**ATTN: Aquifer Exemption**

On behalf of the Natural Resources Defense Council (“NRDC”), which has 2.4 million members and activists, more than 380,000 of whom are Californians, we write to submit our comments on the proposal to expand the current aquifer exemption designation for the Dollie Sands of the Pismo Formation in the Arroyo Grande Oil Field located in unincorporated San Luis Obispo County, near the intersection of Ormonde Road and Price Canyon Road.

**Figure 1:** Site map showing the proposed aquifer exemption boundary (red line), the current aquifer exemption boundary (blue line), the non-compliant UIC wells, and compliant disposal and EOR wells.

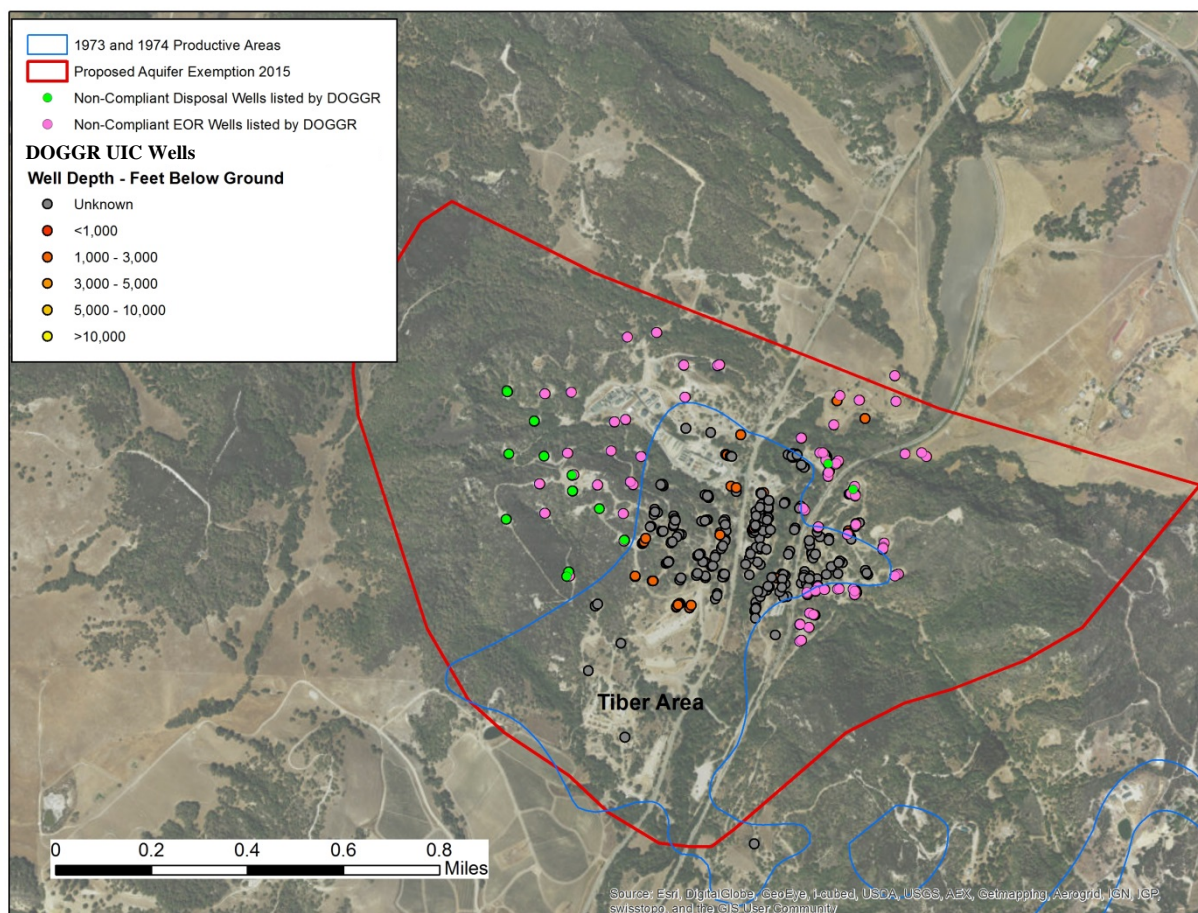
DOGGR and EPA have already exempted the hydrocarbon bearing zone, within the aquifer exemption boundary, as demonstrated in Figure 1. According to the ‘List of Permitted Wells Sent to EPA’<sup>10</sup> spreadsheet, 14 disposal wells (green dots) and 76 EOR wells (pink dots), all of them non-compliant, are located within the proposed aquifer exemption (“AE”) boundary (red line), yet outside of the currently exempted, hydrocarbon bearing aquifer boundary (blue line). The hydrocarbon bearing unit was based on a shapefile provided through DOGGR’s FTP website, which delineated the spatial boundaries for the 1973 and 1974 oil productive units. However none of the active UIC wells located within the exempted, hydrocarbon bearing aquifer were listed in the ‘List of Permitted Wells Sent to EPA’ spreadsheet suggesting they are in-compliance with SDWA.

EPA must not grant an aquifer exemption for disposal wells based on 40 CFR §146.4(b)(1), for a non-producing portion of the aquifer that is also not demonstrated to be suitable for economical hydrocarbon recovery. While the applicant claims, “Hydrocarbons are distributed throughout the oilfield reservoir, both vertically and aerially” (page 3) the location, distribution, and recovery of the economically producible hydrocarbons are overwhelming located within the already exempted portion (blue line) of the proposed aquifer exemption (red line). Currently, the zone outside the boundary of the existing exemption is host mostly to disposal wells.
